Access Compliance Report

Public Rights-of-Way

(Curb Ramps)

Intersection ID: 46190	Main Street: YAUPON_RD	Cross Street: LUSTRE_RD	Location: NW
ADA ID: A6375B179675	Ramp Type: PerpDiag	Initial Pass/Fail: Pass	Overall Compliance: No
Severity Score: 0.25			
Codes/Mitigation Info/Possible Solution		Field Measurements/Component Compliance

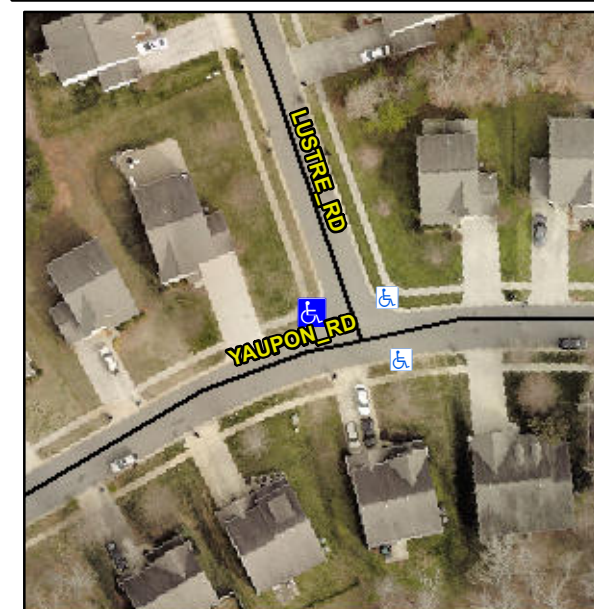
Not Found, R304.5.3, R304.2.1, R305.2

Compliance	Description	Data	Compliance	Description	Data
N/A	Ramp Length (in)	70.0	Yes	Ramp Slope (%)	6.2
Yes	Ramp Width (in)	48.0	No	Ramp XSlope (%)	3.7
N/A	Flare Type LT	Sloped	N/A	Flare Type RT	N/A
N/A	Flare Slope LT (%)	6.3	N/A	Flare Slope RT (%)	0.7
N/A	Flare Traversable LT?	No	N/A	Flare Traversable RT?	No
No	Landing Length (in)	46.5	Yes	DWS Provided?	Yes
Yes	Landing Width (in)	48.0	Yes	DWS Contrast?	Yes
Yes	Landing Slope (%)	1.8	Yes	DWS Length (in)	24.0
No	Landing X Slope (%)	5.0	Yes	DWS Full Width?	Yes
N/A	Landing Curb? (Y/N)	No	No	DWS Offset (in)	5.0
N/A	Shared Landing?	No			
Yes	Gutter Ponding?	No	Yes	Gutter Slope (%)	3.7
Yes	Gutter Lip Ht (in)	0.0	No	Gutter X Slope (%)	3.9
N/A	Painted X Walk1?	No	N/A	Painted X Walk2?	No
	X Walk 1 Direction	To S		X Walk 2 Direction	To E
N/A	X Walk 1 Width (in)	N/A	N/A	X Walk 2 Width (in)	N/A
	X Walk 1 Slope (%)	4.3		X Walk 2 Slope (%)	2.0
	X Walk 1 X Slope (%)	1.9		X Walk 2 X Slope (%)	3.2

N/A	Ramp inside XWalk1?	N/A	N/A	Ramp inside XWalk2?	N/A
	Road Slope (%)	3.6	N/A	Clear Space?	Yes
	Road X Slope (%)	2.2	N/A	Clear Space to XWalk (in)	N/A
Yes	Any Obstructions?	No	Yes	Storm Grate/Utility Hazard?	No
	Obstruction Type			Storm Grate/Utility Type	
		N/A			N/A
		Yes		Surface Condition? (G/P)	Good

Remove & Replace Curb Ramp With Two New Directional Ramps or Equivalent. Remove & Replace Gutter.
